TRANS/WP.29/562

DRAFT 01 SERIES OF AMENDMENTS TO REGULATION No. 80
(Strength of seats and their anchorages)

Note: The text reproduced below was adopted by the Administrative Committee (AC.1) of the amended 1958 Agreement at its fifth session, following the recommendation by the Working Party at its one-hundred-and-eleventh session. It is based on document TRANS/WP.29/R.793, as amended (TRANS/WP.29/534, paras. 75 and 137).

Figure 1

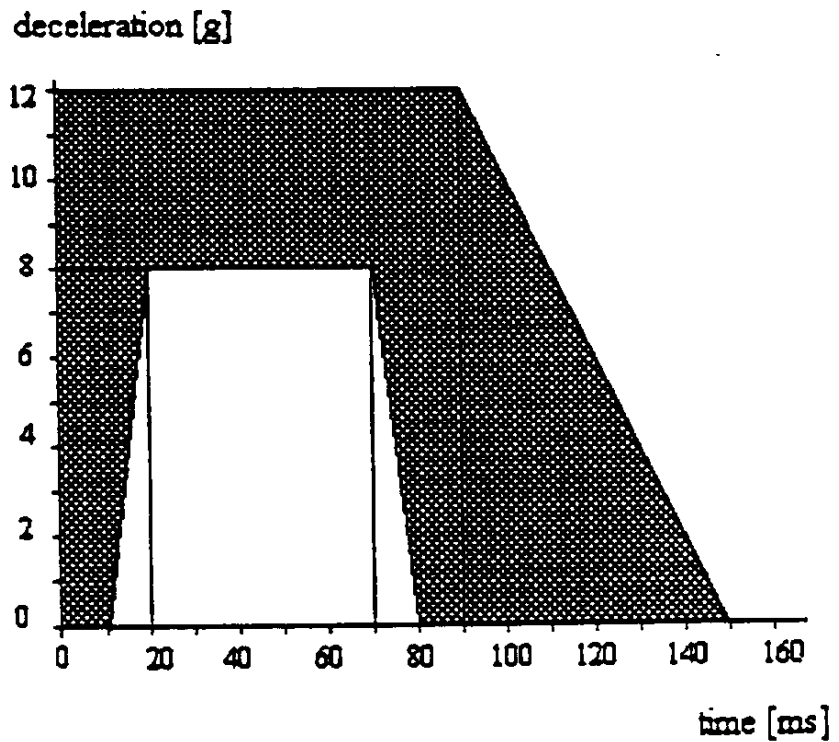
3.4.2. The deceleration of the trolley during the impact test shall be in accordance with the provisions shown in Figure 1 below. Except for intervals totalling less than 3 ms, the deceleration time history of the trolley shall remain between the limit curves shown in Figure 1.

3.4.3. Furthermore, the average deceleration shall be comprised between 6.5 and 8.5g.

Appendix 5 - Figure 1

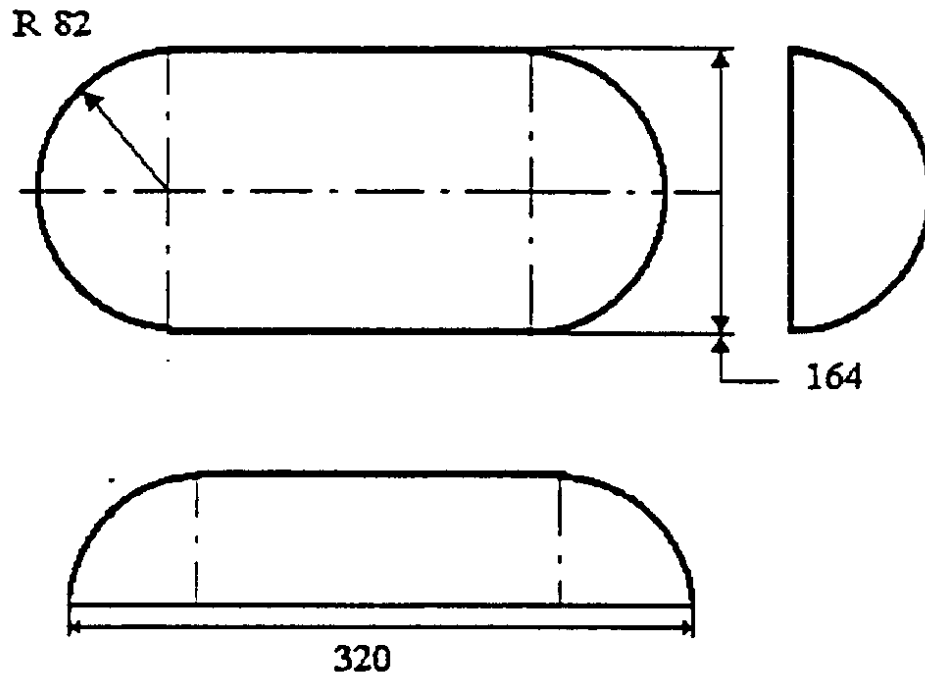
2. Static tests.
 - 2.1. Test apparatus
 - 2.1.1. This consists of cylindrical surfaces with a radius of curvature equal to 82 ± 3 mm and a width:
 - 2.1.1.1. at least equal to the width of the seat-back of each seating position of the seat to be tested for the upper form,

- 2.1.1.2. equal to $320 -0/+10$ mm for the lower form as shown in Figure 1 of this appendix.
 - 2.1.2. The surface resting against the parts of the seat shall be made of a material the hardness of which is not less than 80 Shore A.
